Memorandum

To	North Dakota Public Service Commission	Pages	3
Subject	Case Number PU-18-280 Emmons-Logan Wind Energy Center Modifications of Energy Conversion Facility and Site Plan		
From	Emmons-Logan Wind, LLC		
Date	March 17, 2019

Project Location

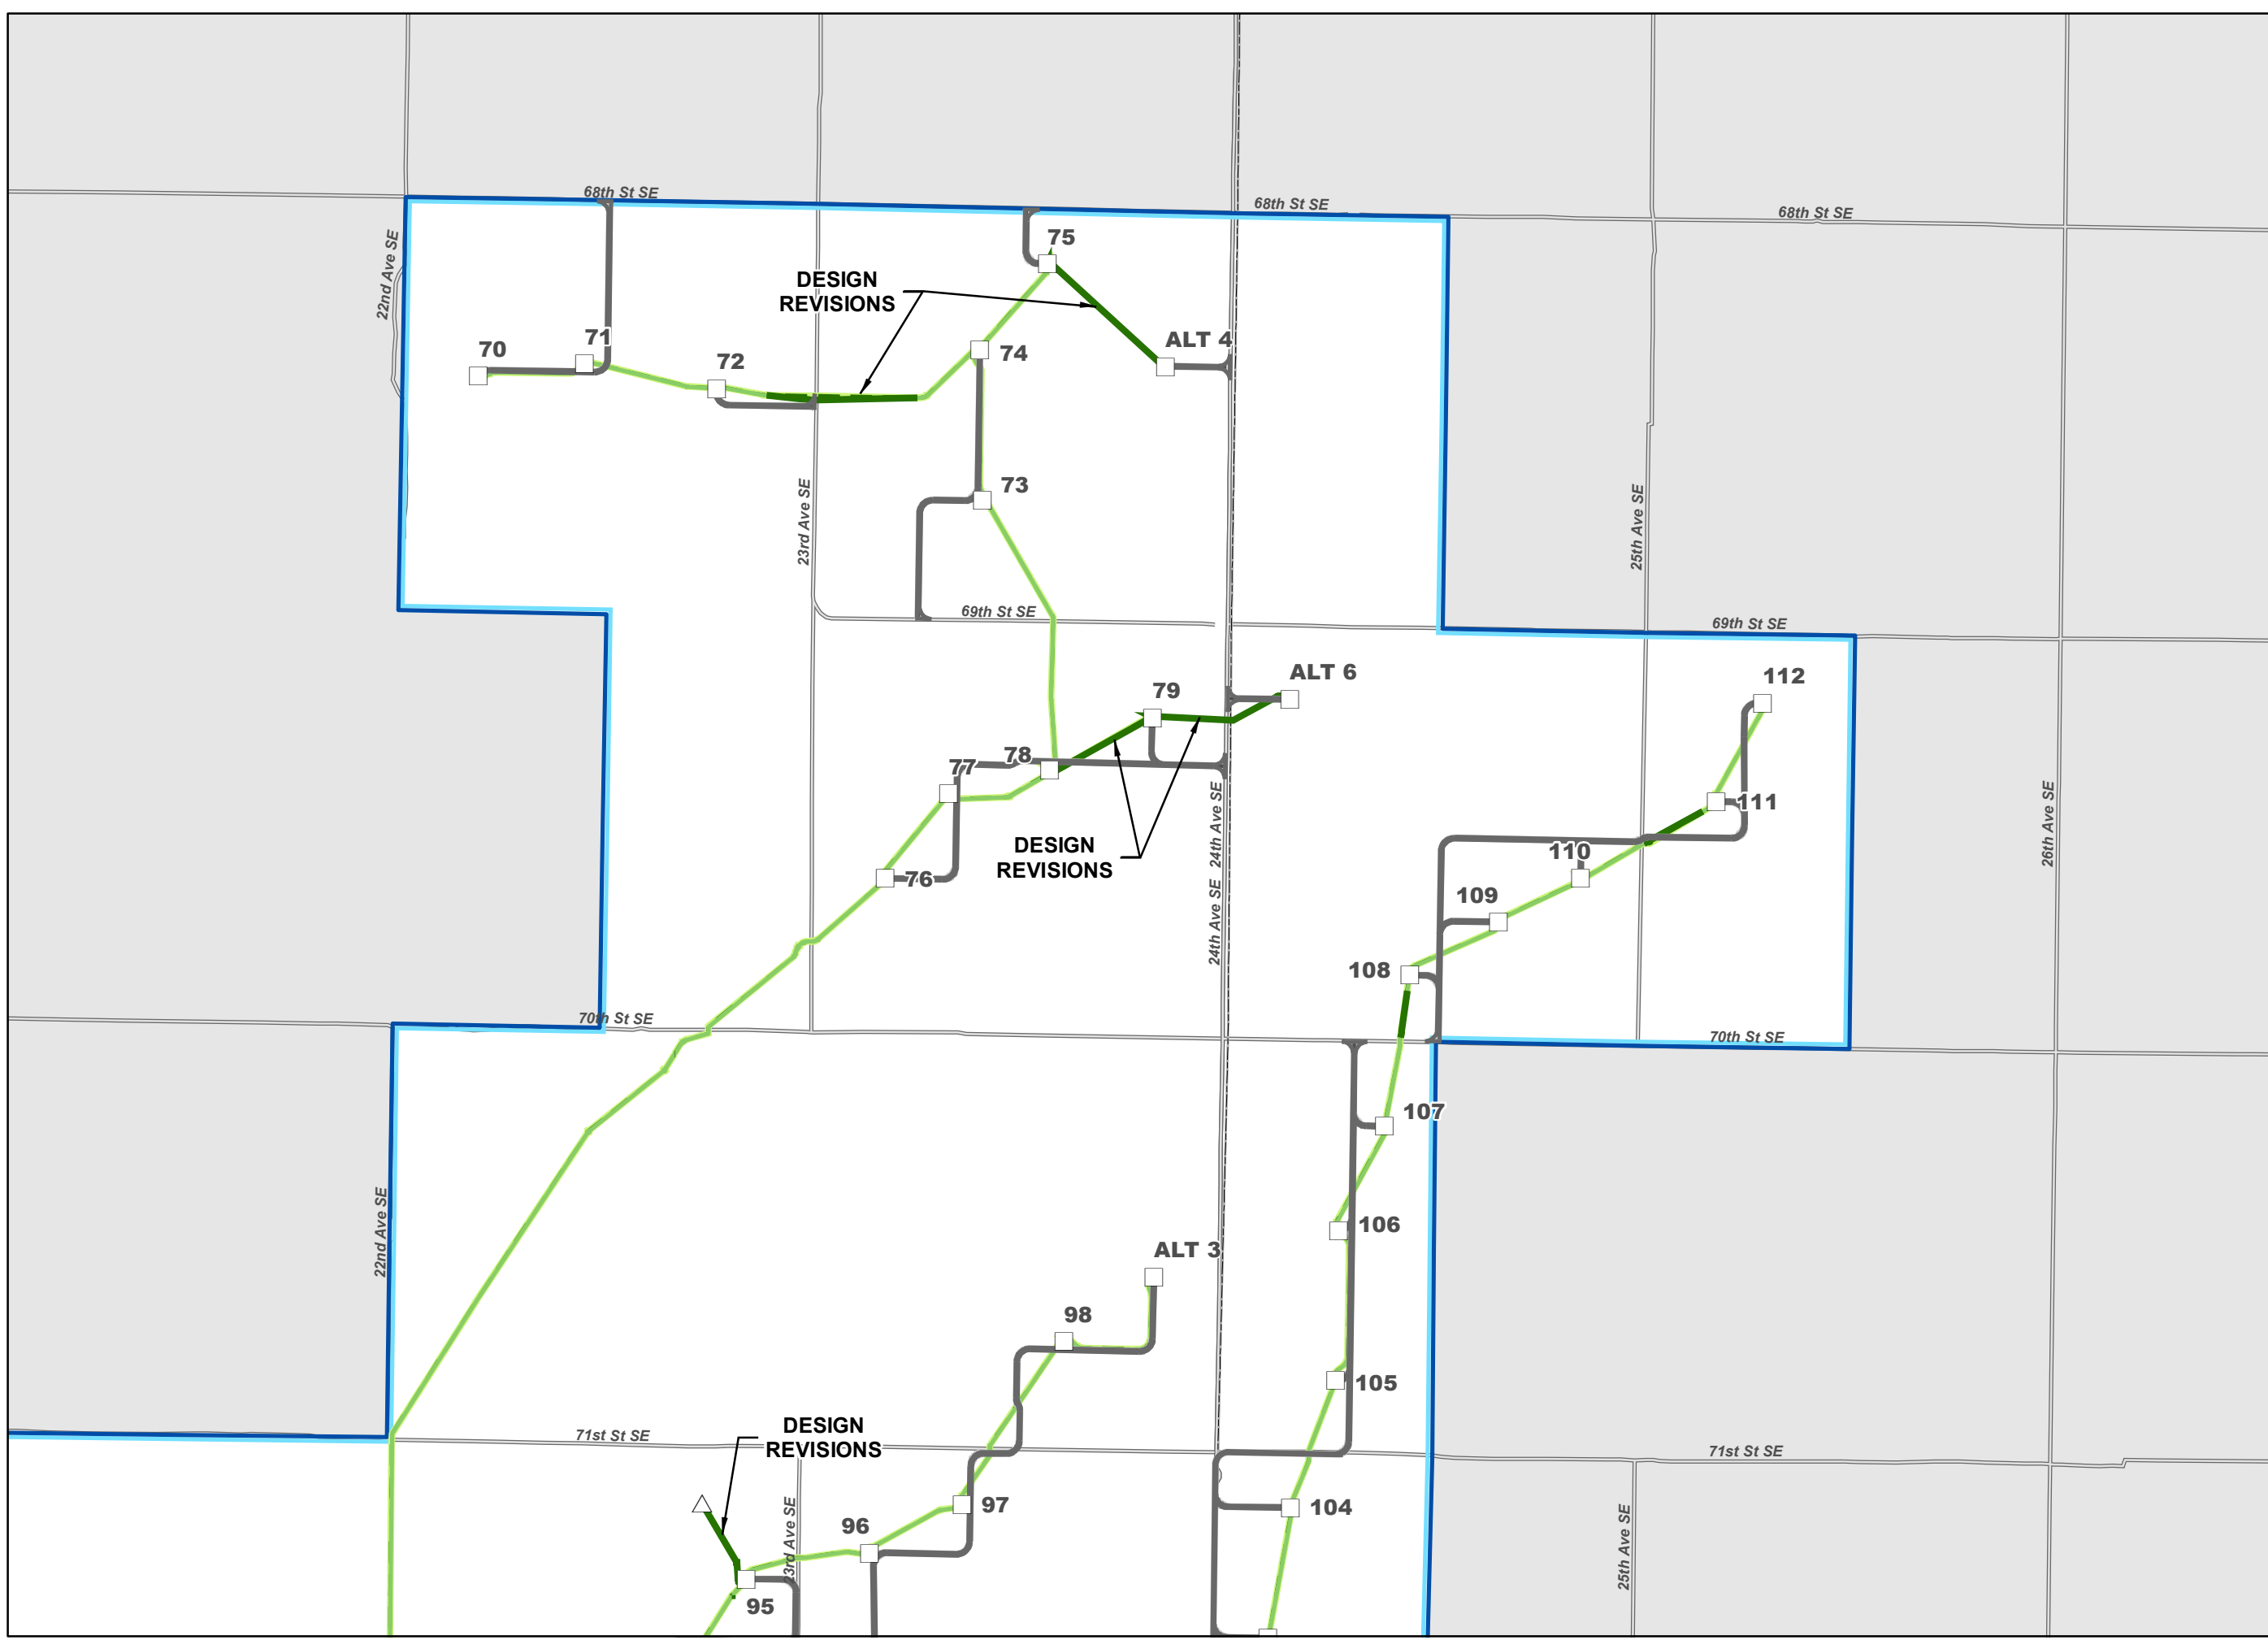
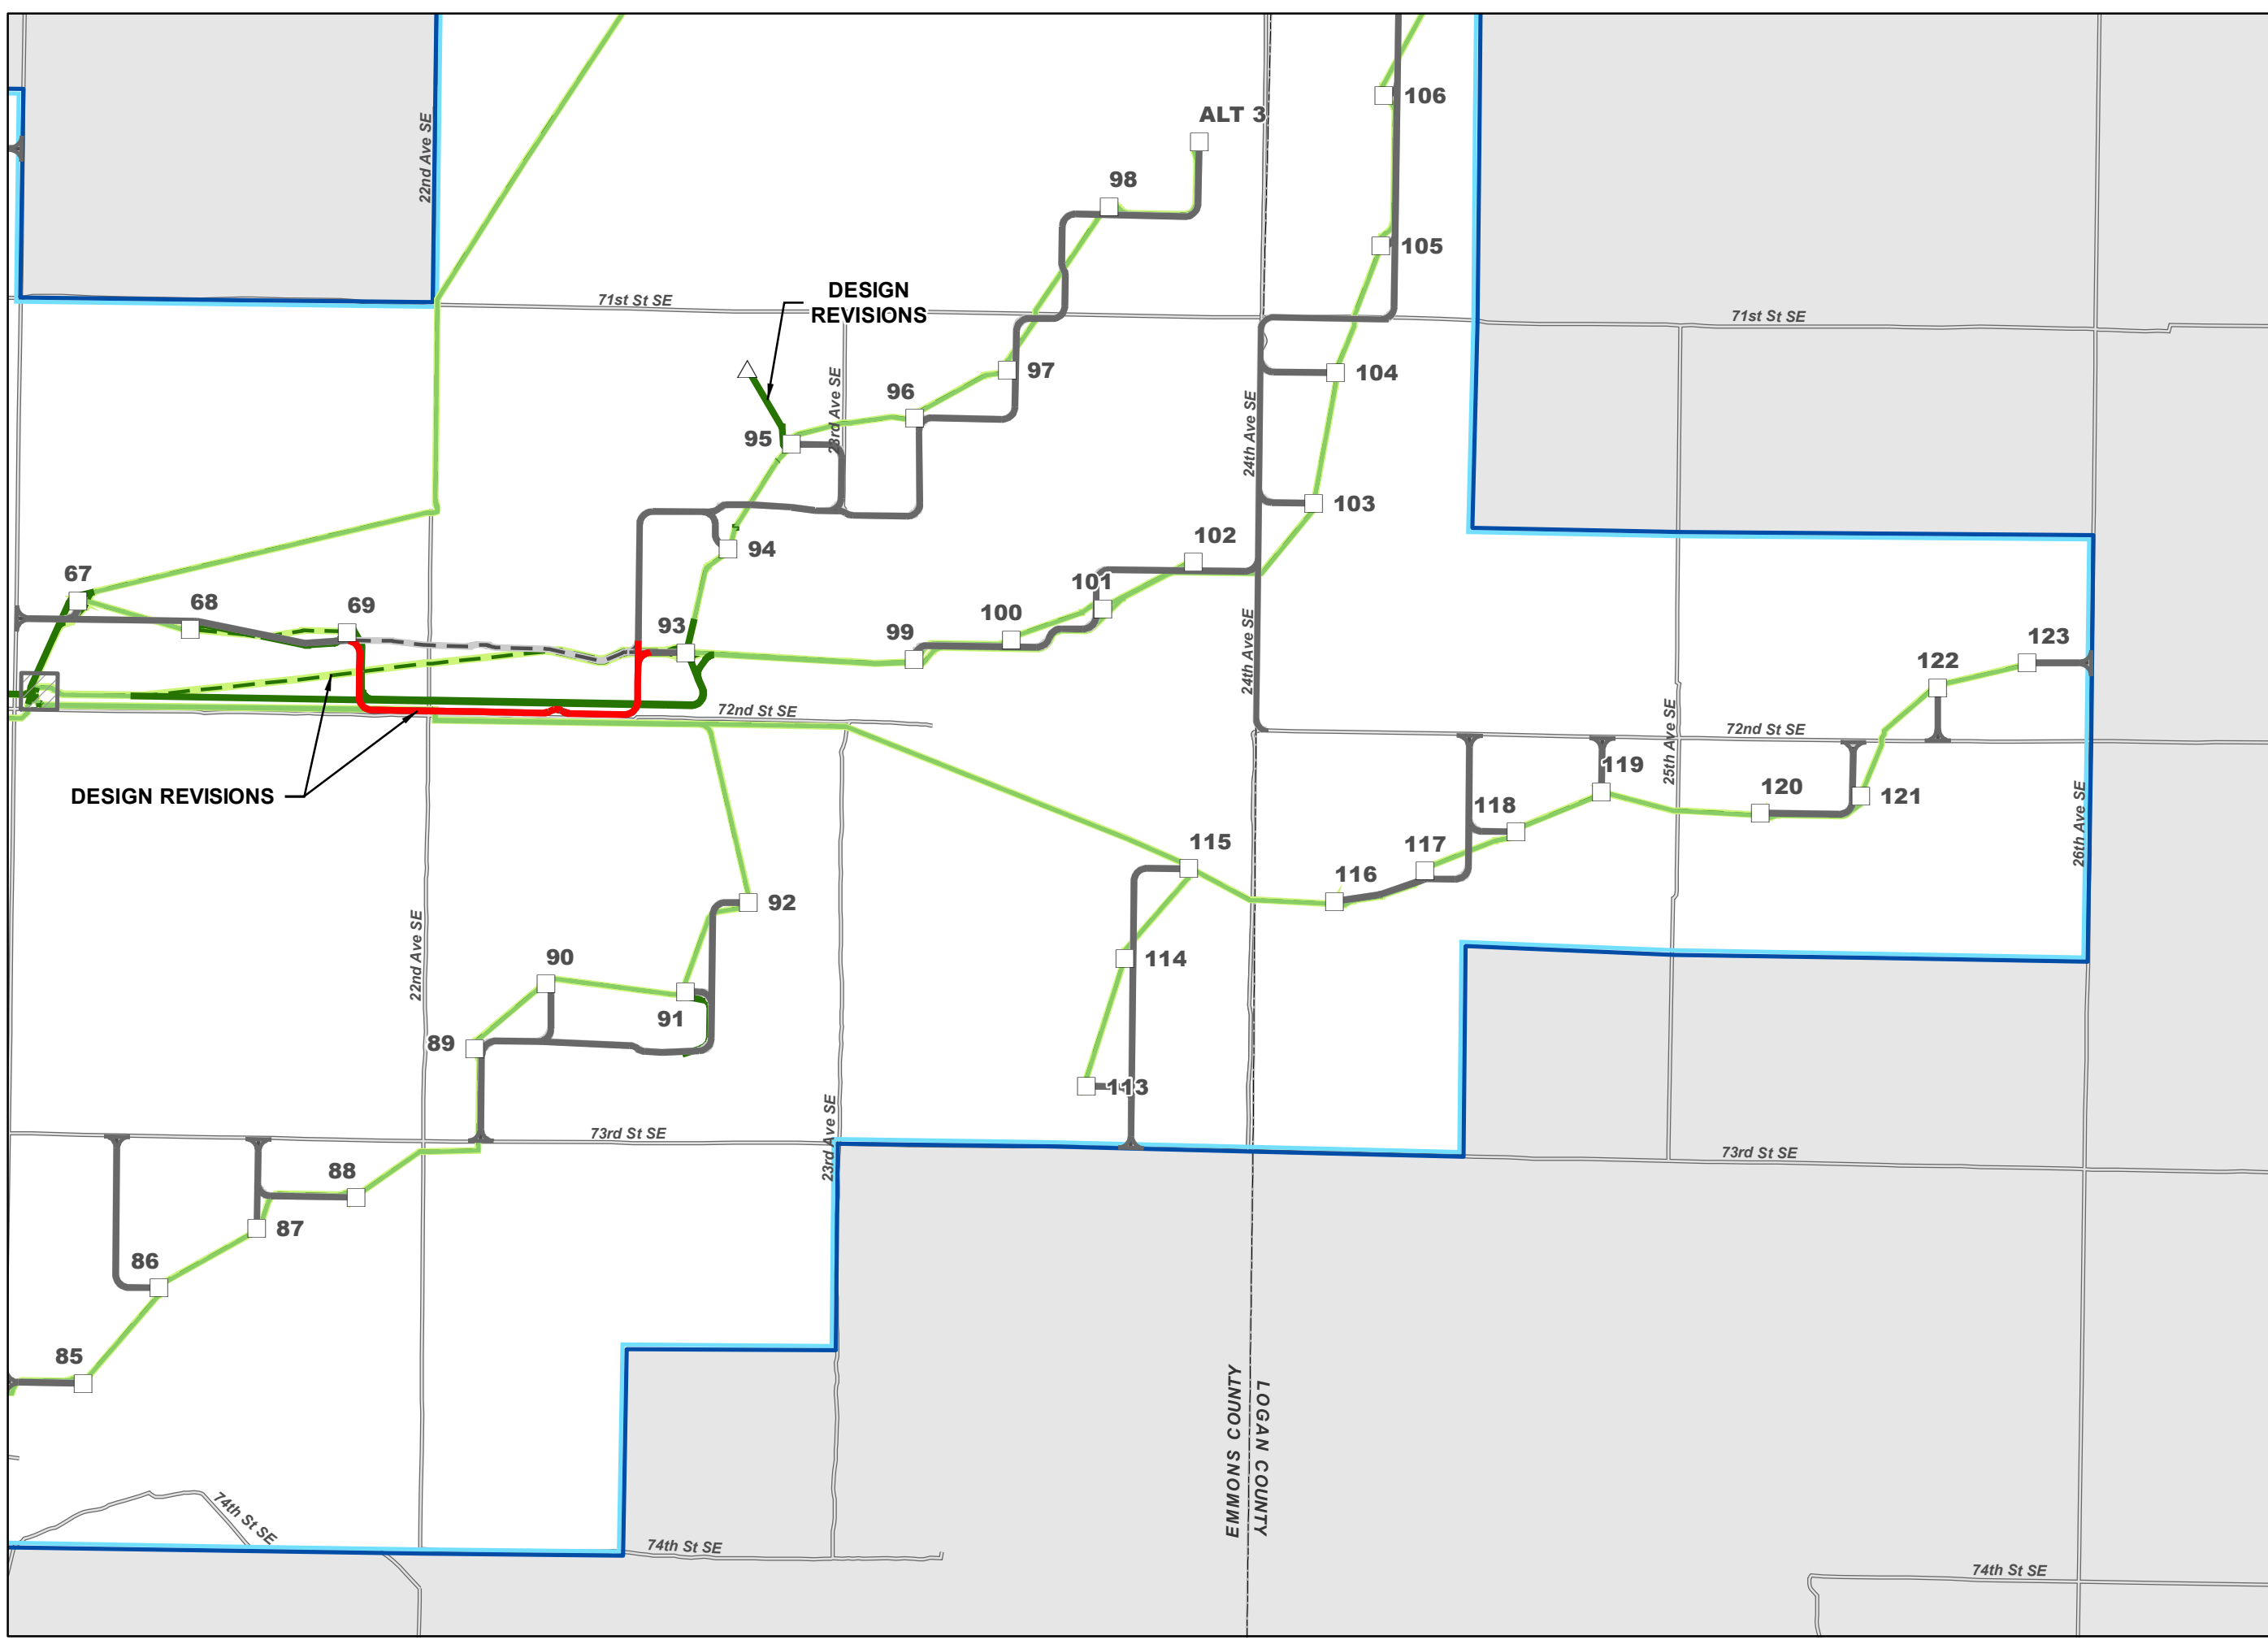
Emmons-Logan Wind proposes certain minor Project Site Plan modifications, including changes to certain collection lines and two access roads. Attachment 4 illustrates locations of the Site Plan modifications, whereas modifications that are imperceptible at the map scale can be viewed using the GIS shapefiles (Attachment 16). Most collection line changes are a result of the turbine model modification, but the collection lines between turbine 64 and the 230 kV substation and between turbine 69 and 93 are a result of landowner requests. This same landowner requested the access road change between turbine 69 and 93 as well. The access road to turbine 49 was also modified to accommodate preferred farming practices of the landowner. Although turbine locations have not changed, new numbers have been designated for most turbines due to the reassignment of proposed and alternative turbines (Attachment 3). The Project Site Plan modifications occur in areas previously surveyed for wetlands, cultural and tribal resources as described below. Attachments 2, 4, and 5 provide updated site plan maps.
